UNITED STATES PATENT AND TRADEMARK OFFICE

09/398,189

Office Action Summary

Response to Amendment

FIG. 8

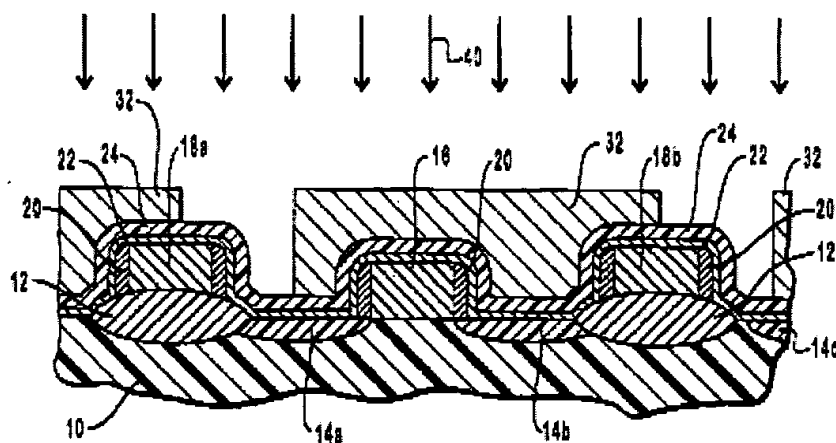
Applicants' next argue that, " However, polysilicon layer 24 of the Doan et al. reference is not describes or suggested as being doped with an impurity".

However, Doan in fig. 8 reproduced below shows :

and in col. 6 lines 17 to 30 describes :

The next step in the method of the present invention is to implant ions, represented by arrows 40 in FIG. 8, into the portions of polysilicon layer 24 which are left exposed and uncovered by implant mask 32. The ions are of a type that preferably comprises a common silicon and polysilicon dopant such as arsenic, phosphorus, argon, or boron. The ions are implanted with an implantation dose in a range from about 1×10^{13} ions per square centimeter to about 1×10^{17} ions per square centimeter. Preferably, the implantation dose is selected to result in approximately 1×10^{15} ions per square centimeter. The implantation energy is selected according to the thickness of polysilicon layer 24, as is commonly known in the art.

Therefore Doan shows and describes polysilicon layer 24 (i.e. the supplemental silicon layer) as being doped with either p-type (boron) or n-type impurity (Phosphorus, argon , etc.) .

Fig.3

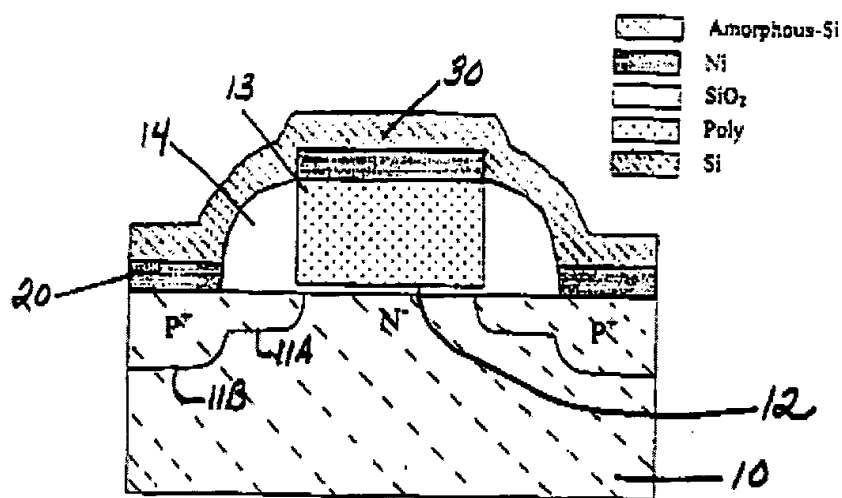
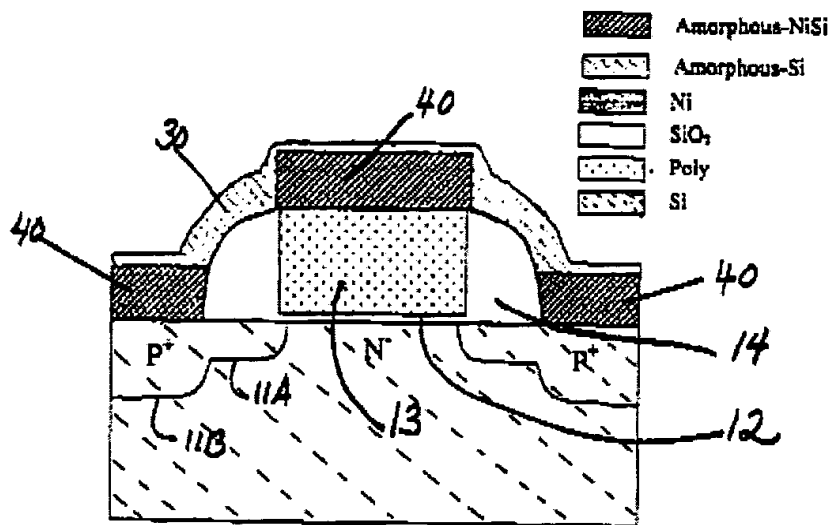
Further, Xaing in fig.. 3 and 4 shows at least two silicon layers 13 and 30 (as shown below) i.e. layer 30 is a supplemental silicon layer.
